Service Bulletin SB0044

Date: November 2002
From: Capstone Technical Support
Subject: Replacing Fuel Filter Strainer Cap O-Ring
 Capstone MicroTurbines

Fuel Filter Strainer Cap (Model C30)

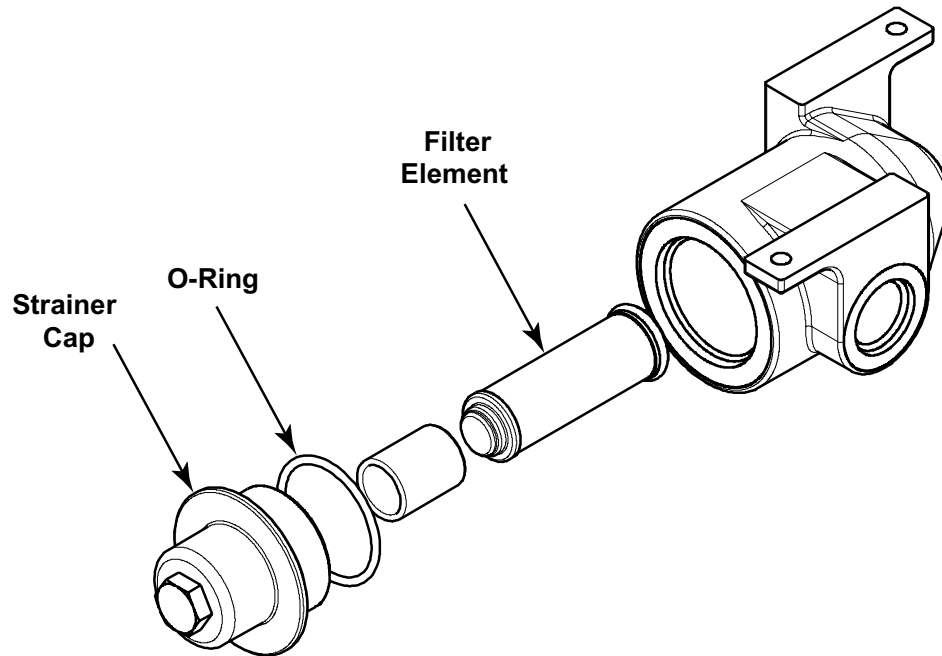
On the Model C30 and C60 MicroTurbine systems listed in the following table, the O-ring in the Fuel Filter Strainer Cap Assembly may deteriorate over time and may cause fuel leaks. To eliminate fuel leaks, the O-ring should be replaced with a newer O-ring 514806.

2. Command the MicroTurbine OFF.
3. Shut OFF fuel and relieve gas pressure into a safe environment.
4. Looking at the front of the MicroTurbine, remove the upper right side panel to access the fuel filter assembly under the engine (see the following figures).

- Remove and discard the existing O-ring inside the Strainer Cap.
- Ensure the O-ring sealing surfaces are clean and free of debris.

- Install the new O-ring 514806. Install the Strainer Cap Assembly in place. Tighten the Strainer Cap to a torque of 50 to 55 lb ft (600 to 660 lb in).
- Turn on the fuel.
- Start the MicroTurbine.
- Test the system for fuel leaks.
- Shut down the system and replace the MicroTurbine side panel.
- Submit a Field Service Report to Capstone to acknowledge the work is complete.
